Service Bulletin

Bulletin No.: PIT5374

Subject: Headlight Performance (BCM Calibration and Bulbs)

Models: 2015 GMC Sierra
2014 GMC Sierra 1500

4092519

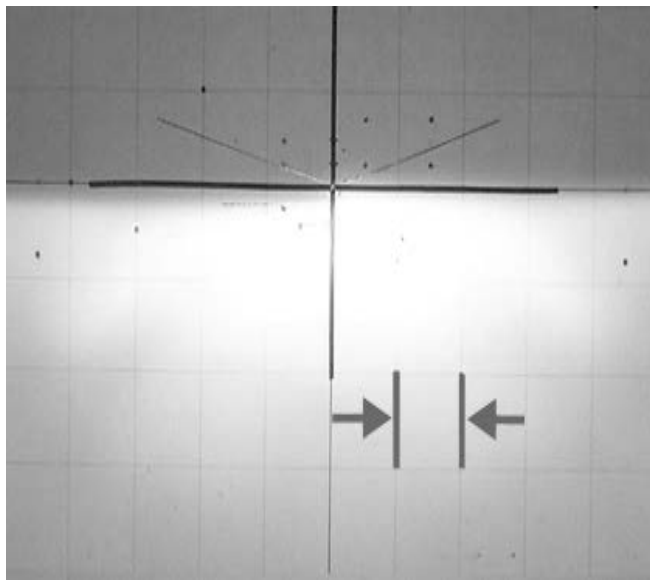
2. Replace both headlight bulbs with updated bulb part number 23342527. **IMPORTANT:** Verify the correct bulb is being installed by confirming the following markings on the bulb:

1. 28432
2. HIR2+30

Important: When installing the new headlight bulbs, do not touch the glass and pay close attention that the bulbs are fully seated into the headlight housing. If the bulb is not properly installed it can lead to an incorrect light pattern. A beam pattern photo with a properly installed bulb is shown below. This photo is of a GMC Sierra Low beam pattern (1 Lamp with opposite lamp blocked) on wall/aiming screen at 25 ft (7.62 m). Each block division is approximately 10.5" (26.67cm)

4092365

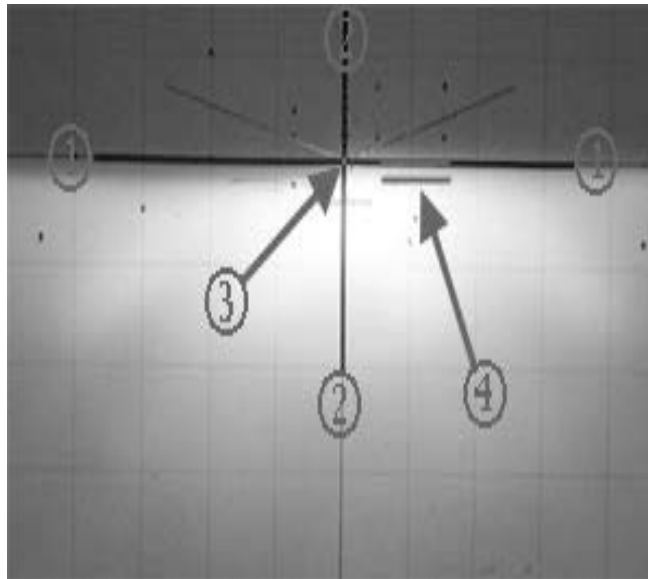
11. On this vehicle you will be verifying the vertical aim of the cutoff (top of the beam pattern) on the right side of the "step" in the beam pattern
12. If the vertical location of the cutoff projected onto the the screen or wall differs from the figure below, then an adjustment to the beam pattern location is necessary.

Note: GMC Sierra Low beam pattern (1 Lamp) on wall/aiming screen at 25 ft (7.62 m)

1. Horizontal Aiming Line
2. Reference line only, Not needed for proper aiming
3. Step in beam pattern
4. Top of beam pattern (cutoff line) positioned at the horizontal aiming line +0 / -0.75" (-19mm)

13. Adjust the vertical headlamp aim adjustment screw until the cutoff (top of the beam pattern) on the right side of the beam pattern step is set between the Horizontal Aim Line and 0.75 (19mm) inches below
14. Repeat the aiming procedure for the passenger's side headlamp while blocking the light from projecting onto the screen from the driver's side headlamp.
